**FINAL DRAINAGE REPORT**  
for  
**LOT 1 BLOCK 1, JOHNSON VACATION**

Falcon, Colorado

**January 26, 2023**

**PCD File No: PPR-21-067**

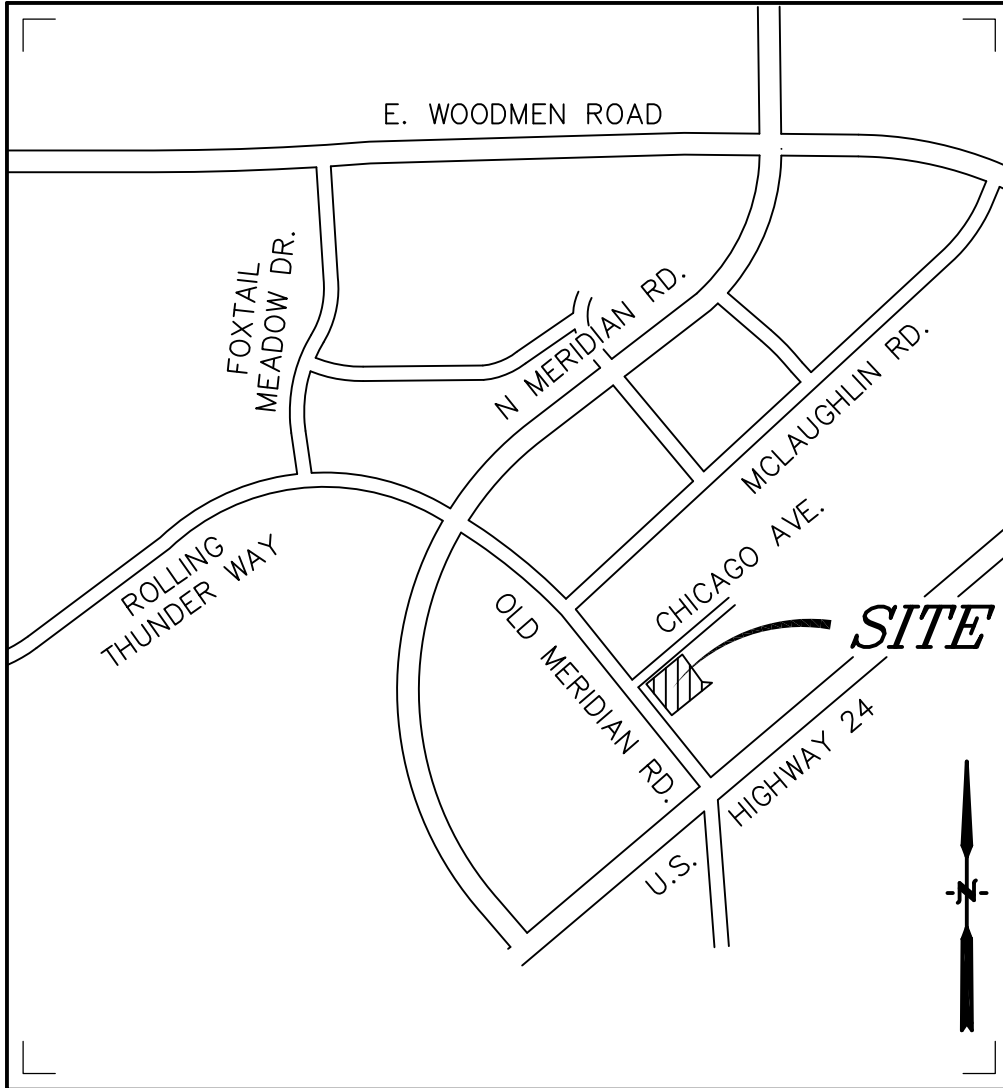
Drainage ditch along HWY 24 will be used to convey flows to outfall area per attached map below. State the ditch is in acceptable condition and able to convey flow

Include a map in the appendix that depicts the flow from the site to its final downstream outfall area and explain this routing in the narrative. Provide statement that the HWY 24 drainage ditch is in suitable condition and that no negative downstream effects are expected based on flows from the site. Pond WU over detains flows from the north and west of New Meridian thus allowing flows from Old Meridian and Chicago Ave area basins to be supported in this manner
